PSEGLI Hosting Capacity Map (HCM), Post Launch Industry Feedback & Questions

*Prepared by Industry for PSEGLI-IWG meeting 11 Feb 2021.
Ver. 8 Feb 2021*

Figure 4-1. Comparison of Stage 2 (Left) and Stage 3 (Right) Hosting Capacity Maps

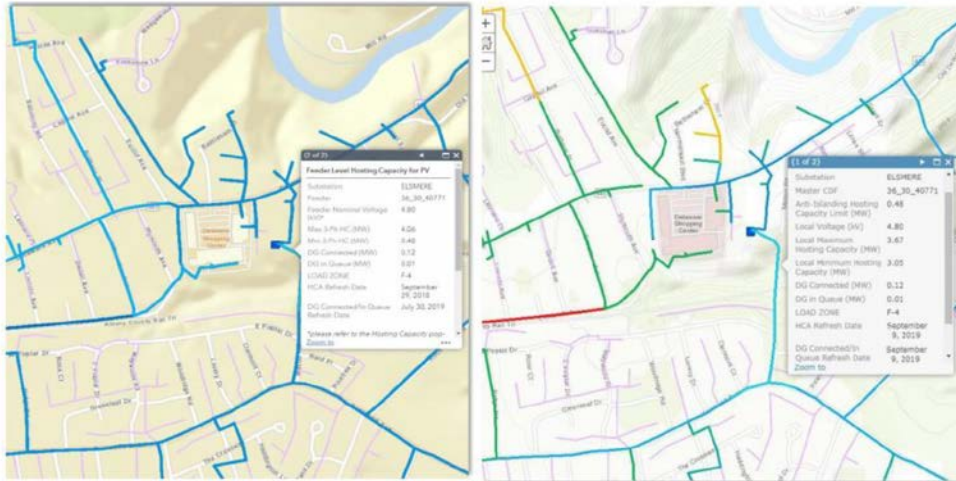
- Industry requests that PSEGLI provide an explicit list of what exact upgrades plan to be included in the 3.1 version.
- Once provided, Industry shall review and if applicable provide feedback on each item, and relative importance. And provide suggestions for other items that may or may not be included.
- Please provide an updated timeline on when the 3.1 version will be launched and whether it can be accelerated.
